CITY OF WEST TORRENS

Notice of Panel Meeting

6.2.1 31 Glengyle Terrace, GLANDORE

DEVELOPMENT NUMBER	21025617
APPLICANT	Anthony Caruso
ADDRESS	31 Glengyle Terrace, GLANDORE SA 5037
NATURE OF DEVELOPMENT	Alterations and additions to the existing dwelling, including an upper level, a garage to side of dwelling and a retaining wall and fence with a combined height of 2.25m
ZONING INFORMATION	<p>Zones</p> <ul style="list-style-type: none"> Established Neighbourhood <p>Overlays</p> <ul style="list-style-type: none"> Airport Building Heights (Regulated) Affordable Housing Building Near Airfields Character Area - Glandore Character Area (WeTo-C3) Hazards (Flooding - Evidence Required) Prescribed Wells Area Regulated and Significant Tree Stormwater Management Urban Tree Canopy <p>Technical Numeric Variations (TNVs)</p> <ul style="list-style-type: none"> Maximum Building Height (Levels) (Maximum building height is 1 level) Minimum Side Boundary Setback (Minimum side boundary setback is 1m for the first building level; 2m for any second building level or higher.

SITE PLAN

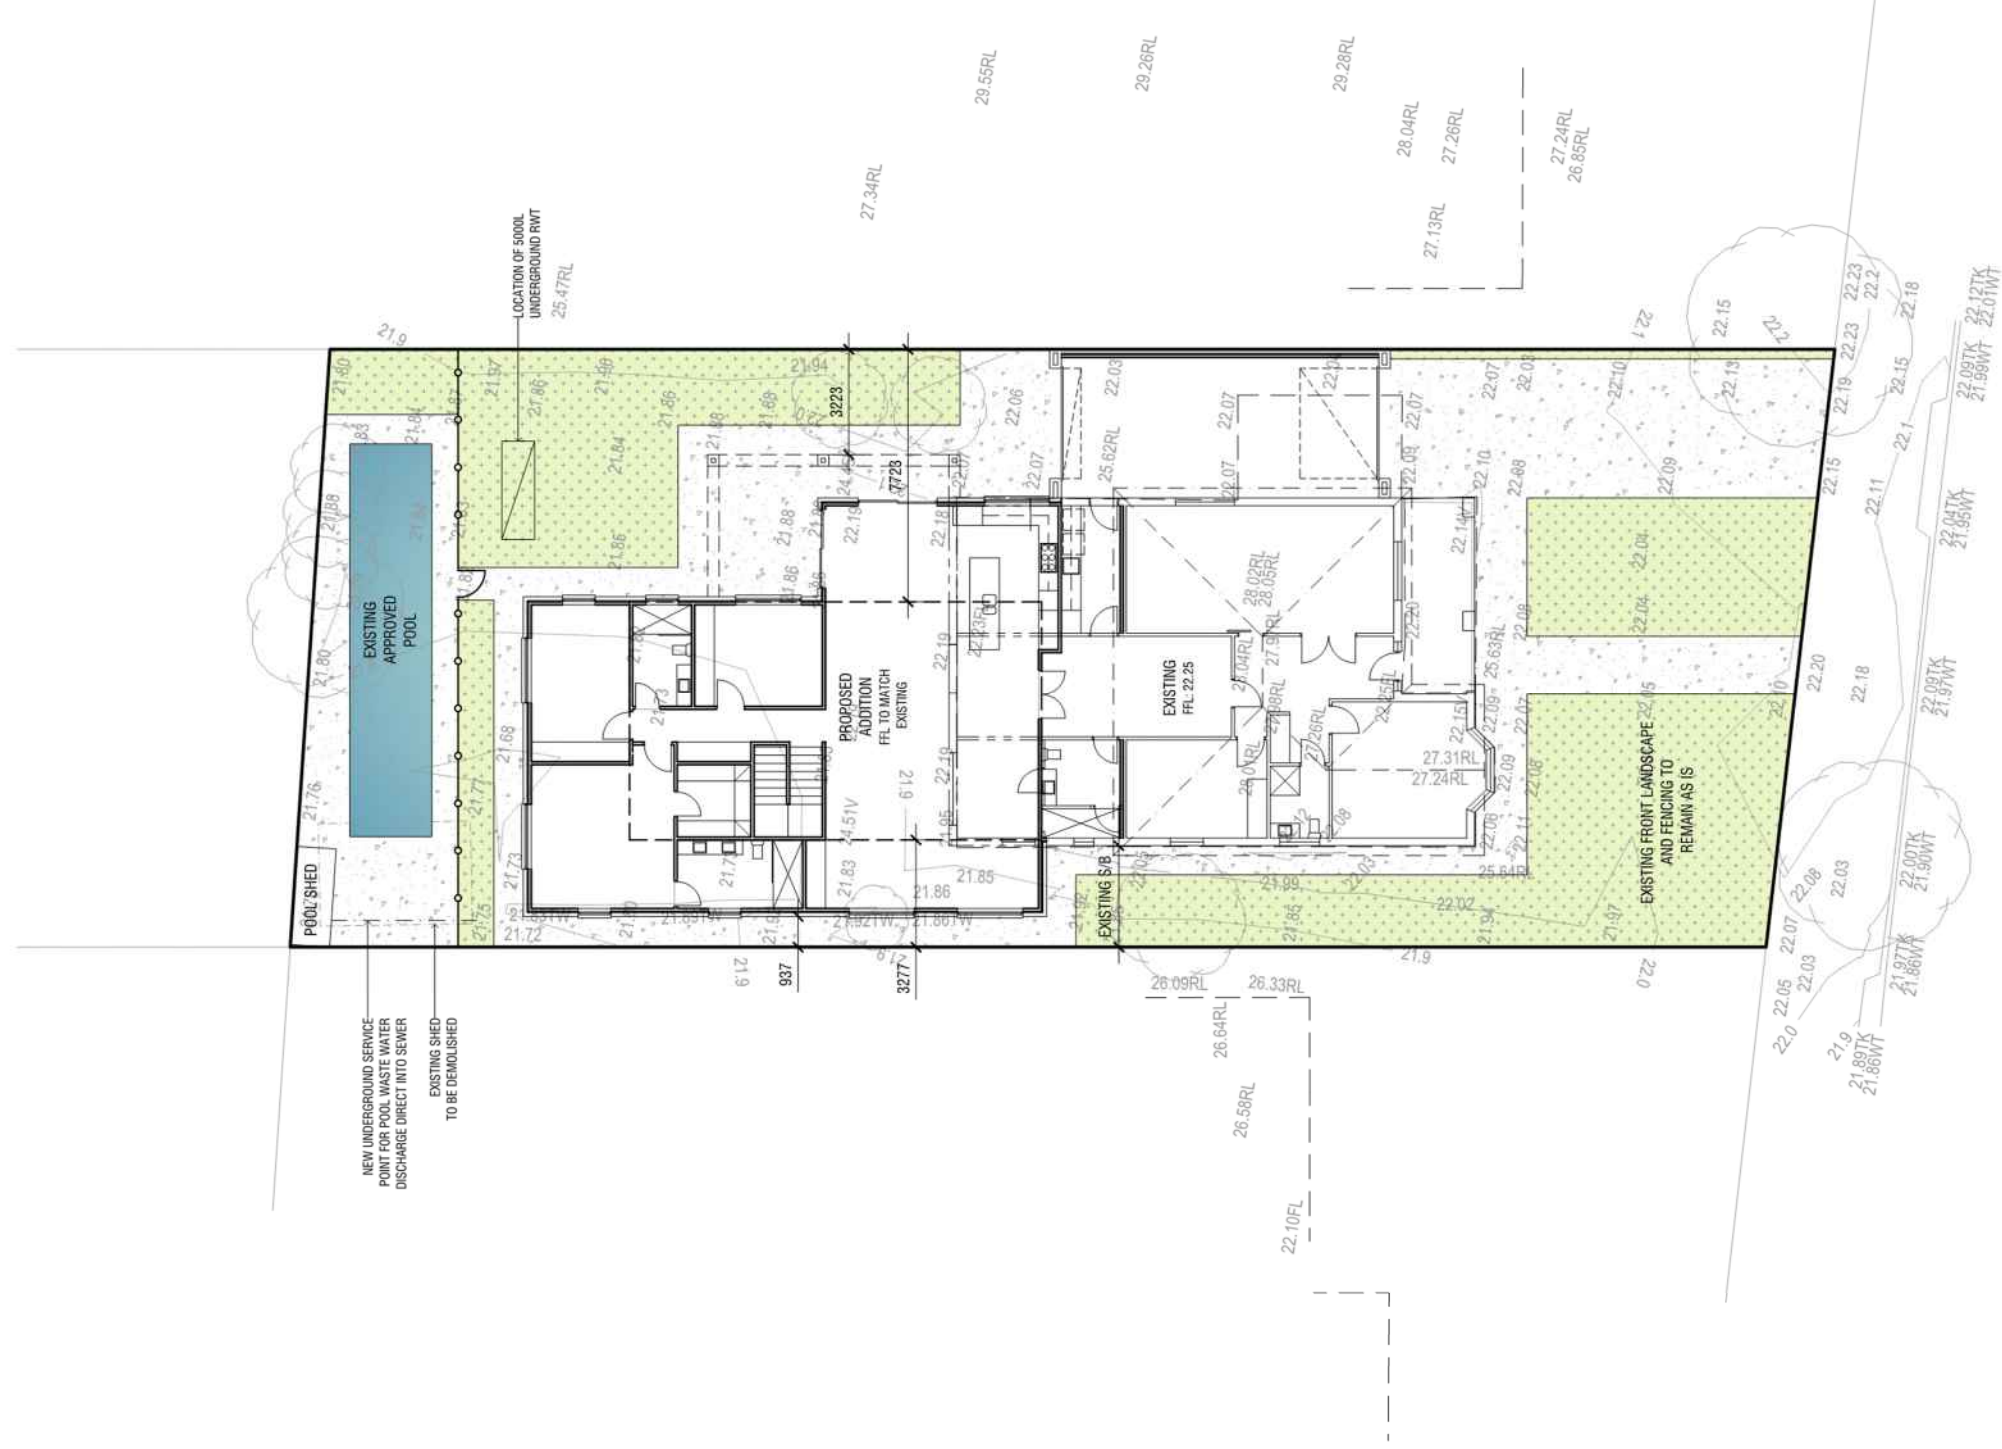
4. The front yard shown as being landscaped (Green space) in the proposal (20-06-035/PD 01, sheet 01 of 08) however as discussed at point 3.b the property has equipment and cars stored on it in a permanent or semi-permanent capacity. There is no landscaping and minimal green space as the

occupants have either cut down, removed, or otherwise let die the previous owners landscaping efforts. The current greenspace consists of shelving along the perimeter of the property with cactus (succulents) type plants in small pots.

I am sorry to let you feel bad with the current situation. My wife loves collecting succulents, as you can see, she planted a lot of small plants not only in our yard but also kerb side. As we are still planning to build the house and all the old underground pipelines will have to be replaced. Before the underground work been done, we are not able to do anything. Once it been done, we will plant plenty small bushes along the front yard and we are more than happy to get some advice from you about what type plant is better looking and easy maintain.

WINTER SOLSTICE - 9AM

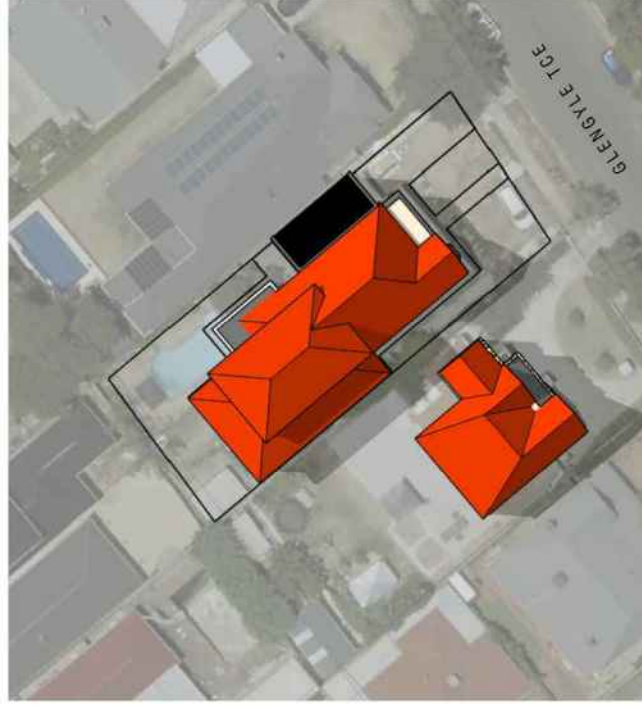
The applicant has provided overshadowing diagrams from an aerial view which have taken into consideration the vertical height of the adjacent property, 33 Glengyle Terrace, to accurately determine the extent of shadows cast by the proposed development. It is acknowledged that the shadows diagrams provided does not show the dwelling addition currently being constructed at 33 Glengyle Terrace, Glandore, instead the red outline is of the existing dwelling footprint. However the concrete foundations to the dwelling addition are evident in the aerial image. Notwithstanding the above, the proposed development will shadow a large portion of the private open space and north facing windows at 9am on 21 June. However, by 12pm a majority of the shadows will have passed that will allow for the minimum of three hours of direct winter sunlight on 21 June, satisfying PO and DPF 3.1 of General Development Provisions - Interface between Land Uses. Additionally, the proposal also satisfies PO and DPF 3.2 of General Development Provisions - Interface between Land Uses as it provides the adjoining dwellings Private Open Space areas with an excess of two hours of direct winter sunlight.

PROJECT	PROPOSED DEVELOPMENT AT 31 GLENGYLE TCE, GLANDORE FOR H QIN
SHEET TITLE	SITEWORK AND DRAINAGE PLAN
PROJECT No.	HWC-21269
DRAWING	C03
REVISION	B

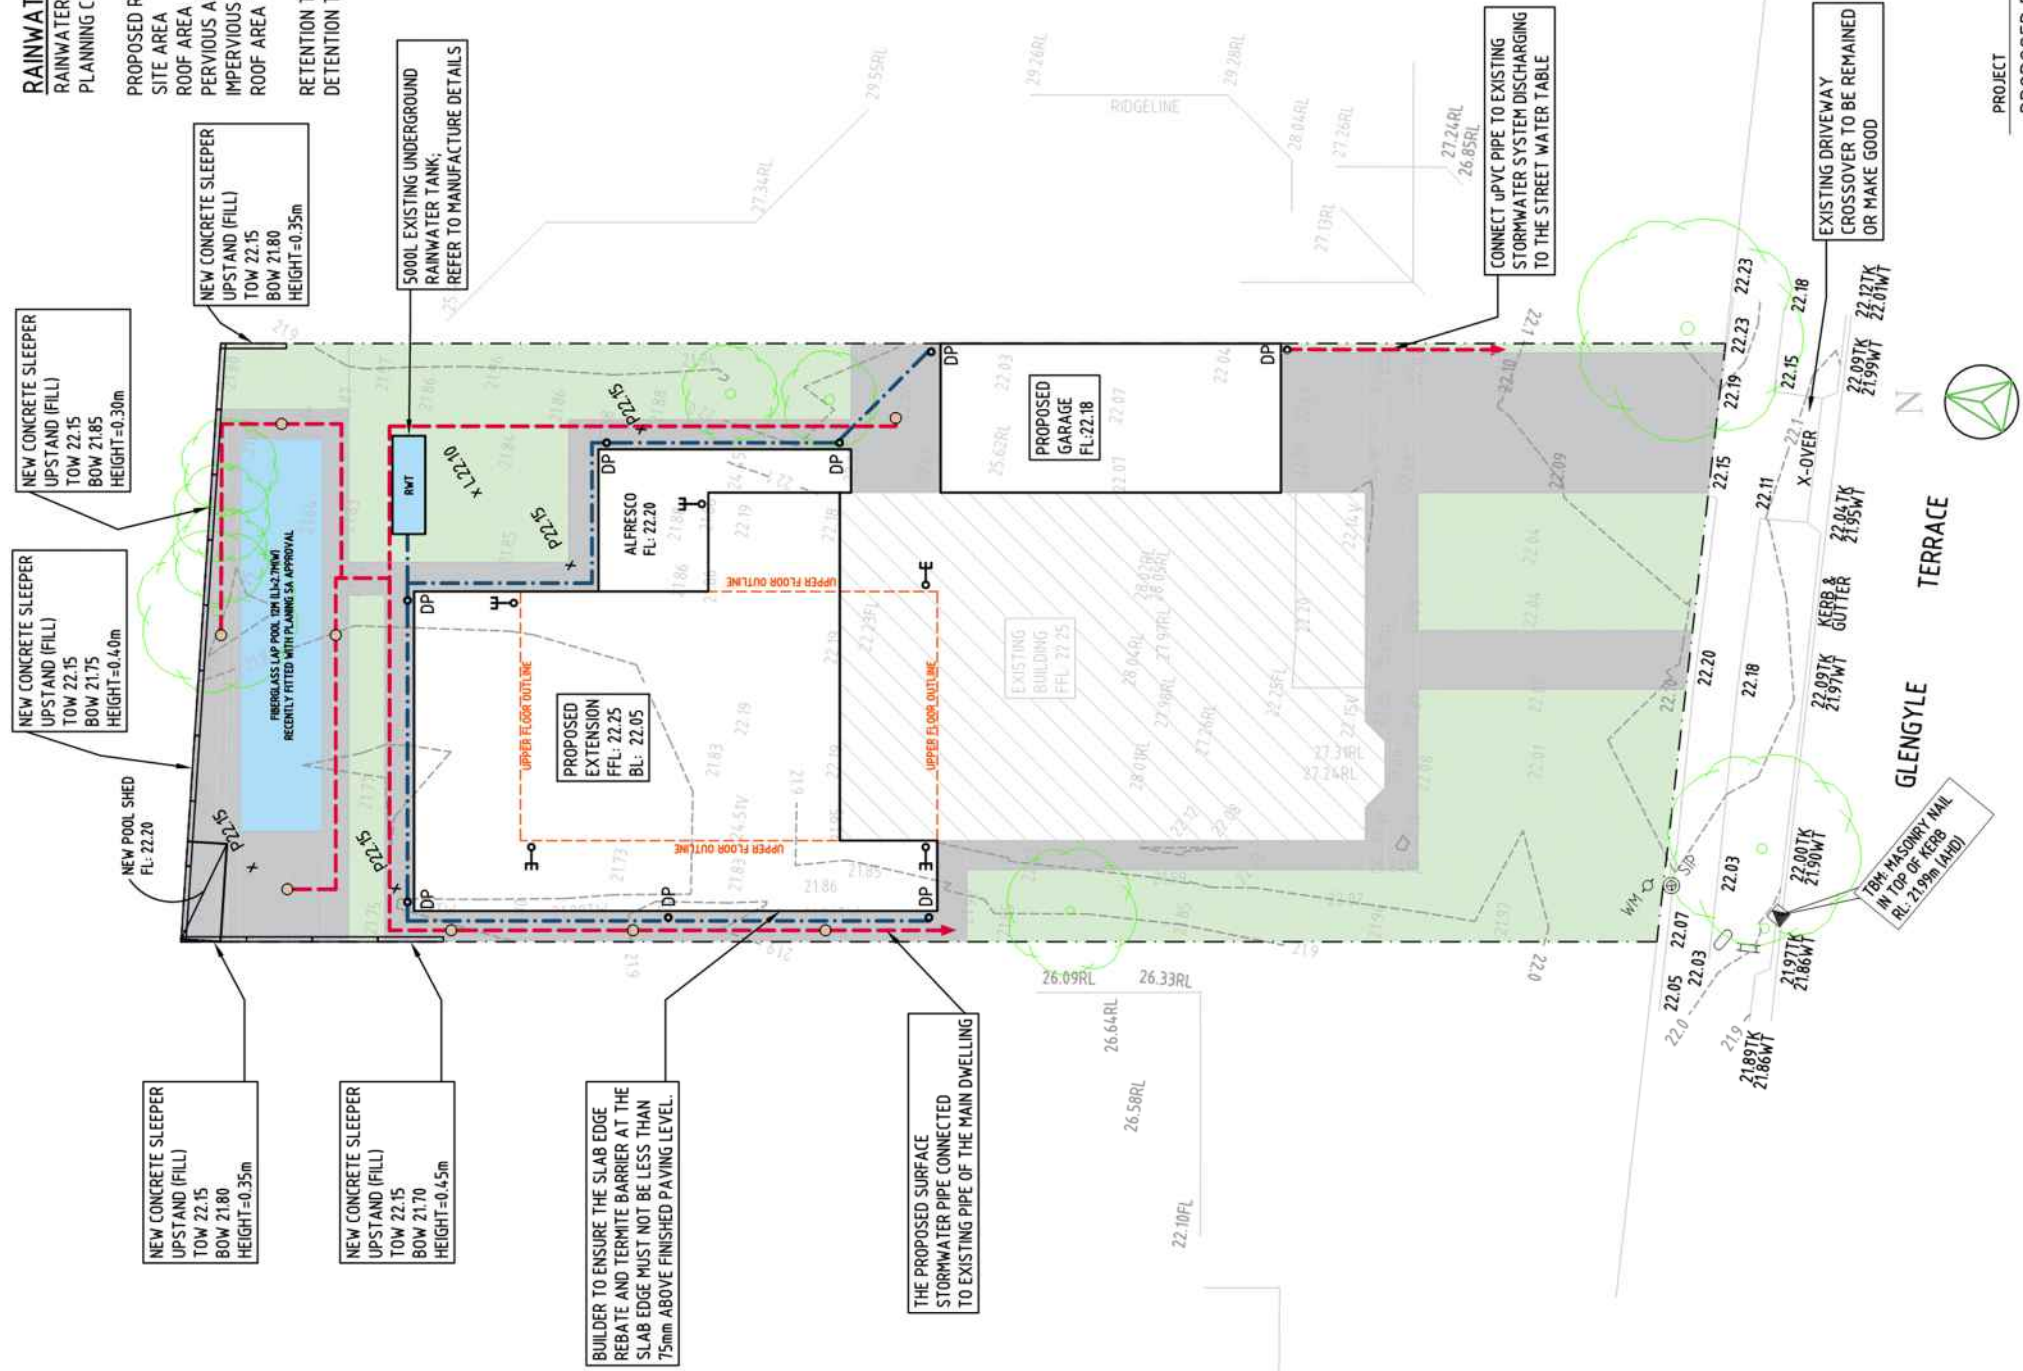
- iv. Has planning permission been given for this tank?
11. Site work and Drainage plan (HWC-21269, DWG C03, rev A)
 - a. No swimming pool is shown, proposed, or illustrated on this plan with 'natural drainage' and a grassed area proposed. As can clearly be seen in image #1 (below) there is now a very large swimming pool in the yard along the back fence.

- a. No swimming pool is shown, proposed, or illustrated on this plan with 'natural drainage' and a grassed area proposed. As can clearly be seen in image #1 (below) there is now a very large swimming pool in the yard along the back fence.
- b. NW corner of the site shows a 3000L 'Detention/Retention rainwater tank' to be installed on a concrete pad on the fence line. All proposed stormwater is to flow from the roof to this tank with the overflow piped and discharged to street water table.
- c. As can be seen from Image #1 this is not possible as a new swimming pool has already

I have attached a copy of right draining plan in this email. There have been some mistakes made by HWC engineer, they did not visit my site nor talk with me before they submit that first draining plan, I am suffered too! I am sorry for this inconvenience! There will be no rain water tank or retaining wall along the fence line. The new small shed in the NW corner is a pumping shed for the pool only. You have nothing to worry about.

The pool location has been updated on the plans and civil to reflect its correct location.

PROJECT	PROPOSED DEVELOPMENT AT 31 GLENGYLE TCE, GLANDORE FOR H QIN
SHEET TITLE	DEMOLITION PLAN
PROJECT No.	DRAWING C02
HWC-21269	REVISION B

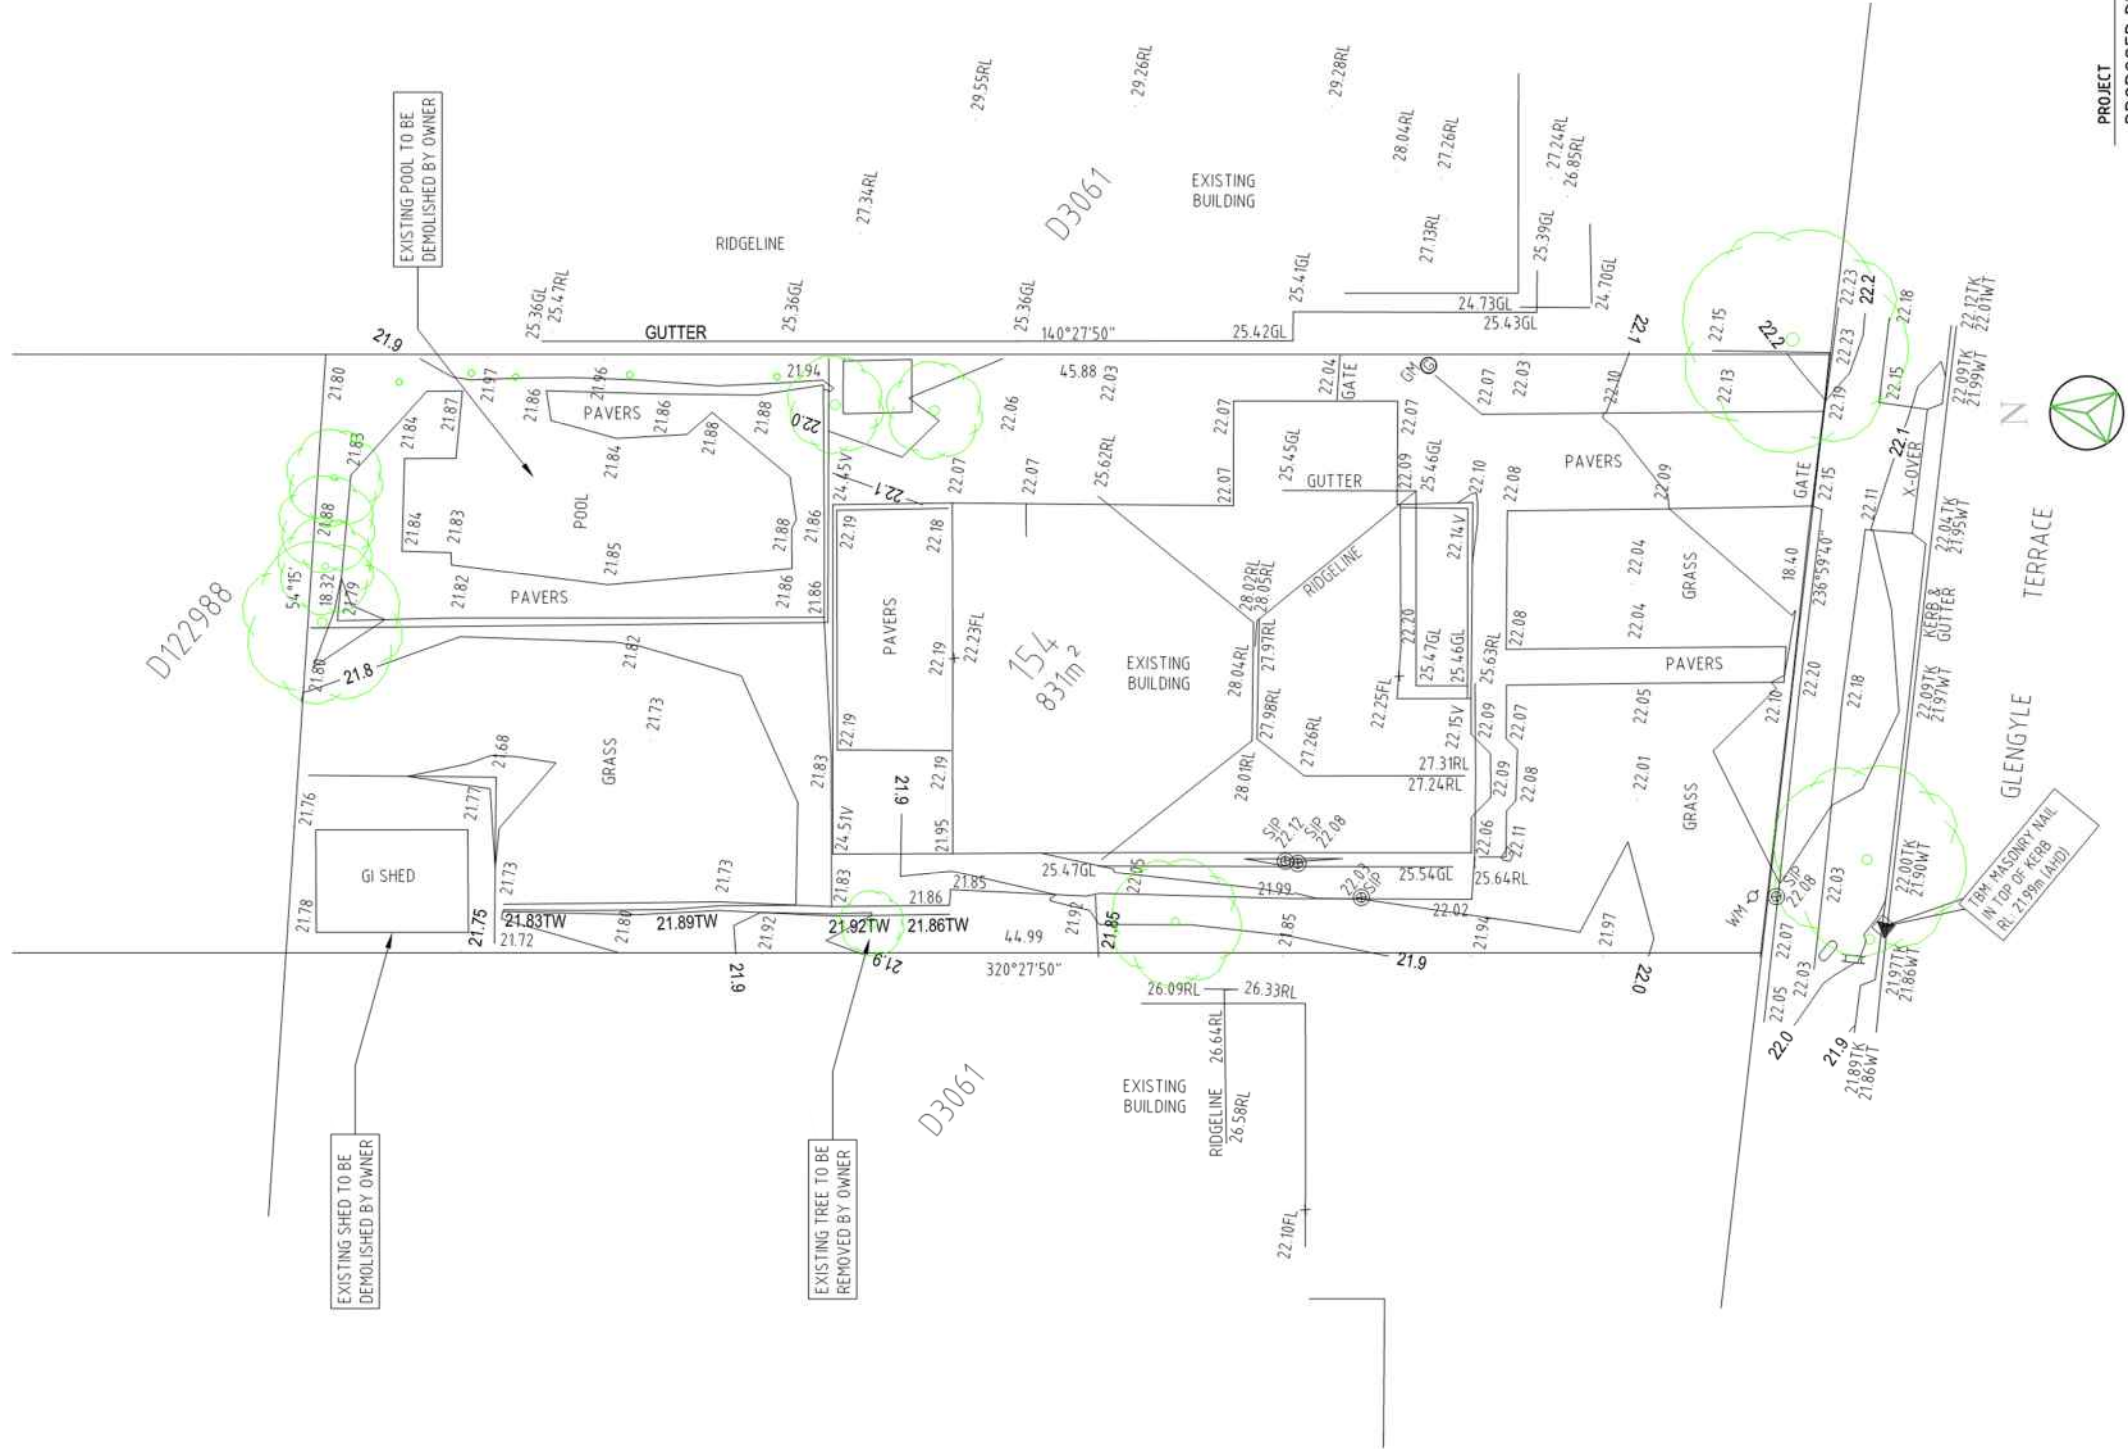
10. Demolition plan (HWC-21269, DWG C02, rev A)
- a. Shows **existing pool** on the NE side to be demolished by owner. This has already been completed and the hole filled as @ 12 Mar 2022.

- i. However, a new, quite large swimming pool has been installed prior to 2022 along the rear fence line as can be seen in Image #1. This swimming pool does not appear in any plans or proposals. What is the impact on the current plan for 31 Glengyle Tce & how does this affect the Site work and Drainage plan (Ref 11)?

- iv. Has planning permission been given for this tank?
 - a. The new pool got an independent approval by Statewide pool supply.
 - b. About that old shed, I do believe that I have the right decide whether keep it and when to remove it.

- c. The underground water tank is inclusive within in the draining plan requested by local council, I have attached a copy in this email.
